# Access Compliance Report

### (Curb Ramps)

Intersection ID: 24195	Main Street: PROVIDENCE_RD	Cross Street: BEVERLY_CREST_BV	Location: NE
ADA ID: A0A0CBB94BA1	Ramp Type: Perp	Initial Pass/Fail: Fail	Overall Compliance: No
Severity Score: 21.25			
Codes/Mitigation Info/Possible Solution		Field Measurements/Component Compliance

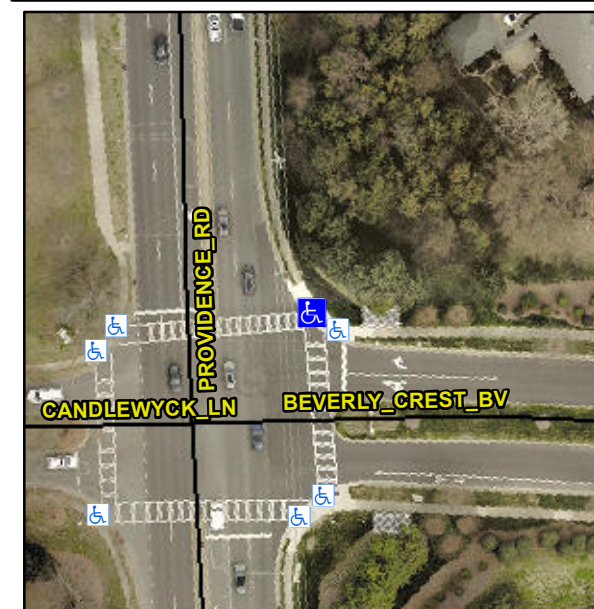
**Not Found, R304.5.1, R304.5.3**

Compliance	Description	Data	Compliance	Description	Data
N/A	Ramp Length (in)	75.0	Yes	Ramp Slope (%)	6.9
No	Ramp Width (in)	39.0	No	Ramp XSlope (%)	6.7
N/A	Flare Type LT	N/A	N/A	Flare Type RT	N/A
N/A	Flare Slope LT (%)	N/A	N/A	Flare Slope RT (%)	N/A
N/A	Flare Traversable LT?	N/A	N/A	Flare Traversable RT?	N/A
N/A	Landing Length (in)	N/A	N/A	DWS Provided?	N/A
N/A	Landing Width (in)	N/A	N/A	DWS Contrast?	N/A
N/A	Landing Slope (%)	N/A	N/A	DWS Length (in)	N/A
N/A	Landing X Slope (%)	N/A	N/A	DWS Full Width?	N/A
N/A	Landing Curb? (Y/N)	N/A	N/A	DWS Offset (in)	N/A
N/A	Shared Landing?	N/A			
N/A	Gutter Ponding?	N/A	N/A	Gutter Slope (%)	N/A
N/A	Gutter Lip Ht (in)	N/A	N/A	Gutter X Slope (%)	N/A
N/A	Painted X Walk1?	Yes	N/A	Painted X Walk2?	N/A
	X Walk 1 Direction	To NW		X Walk 2 Direction	N/A
N/A	X Walk 1 Width (in)	85.0	N/A	X Walk 2 Width (in)	N/A
	X Walk 1 Slope (%)	4.0		X Walk 2 Slope (%)	N/A
	X Walk 1 X Slope (%)	2.1		X Walk 2 X Slope (%)	N/A

**Remove & Replace Entire Ramp.**
